HISTORIC AND DESIGN REVIEW COMMISSION

July 05, 2017

HDRC CASE NO: 2017-313 124 W WOODLAWN **ADDRESS: LEGAL DESCRIPTION:** NCB 1860 BLK 1 LOT 3 & 4 **ZONING:** R-4 CD **CITY COUNCIL DIST.:** 1 **DISTRICT:** Monte Vista Historic District **APPLICANT:** Valerie Clearley **OWNER:** Valerie Clearley **TYPE OF WORK:** Construction of a rear carport

FRONT ELEVATION

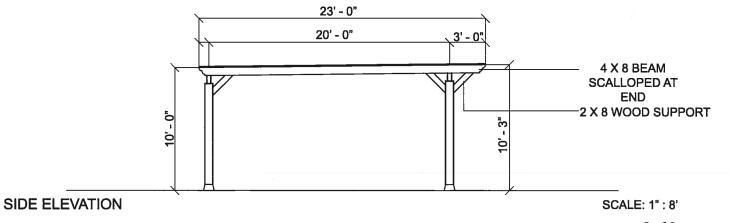
- d. SCALE & MASS The applicant has proposed a 1-story carport structure with a flat roof. The structure will measure approximately ten feet in height. The Historic Design Guidelines state that new construction should be consistent with the height and overall scale of nearby historic buildings and rear accessory structures. The scale of the proposed structure does not impact or visually compete with primary structure on the lot or nearby historic structures, and will visually match the height of the carport located directly to the south on a neighboring property. Staff finds the proposal consistent with the Guidelines.

- e. ROOF The applicant has proposed a flat roof form for the carport. The roof will be constructed of metal to closely match the materiality of the primary structure. Staff finds the proposal appropriate.

- f. MATERIALS The proposed carport will be constructed with concrete footing, 8x8" cedar posts, cedar beams, and 12ft 5V crimp galvanized steel gauge roof panels. The roof will be supported by scalloped cedar beams. The Guidelines for New Construction state that materials should complement the type, color, and texture of those found in the historic district. Staff finds the proposal consistent with the Guidelines.

Staff recommends approval based on findings a through e with the following stipulation:

i. That the applicant meets all setback standards as required by city zoning requirements, and obtains a variance from the Board of Adjustment if applicable.
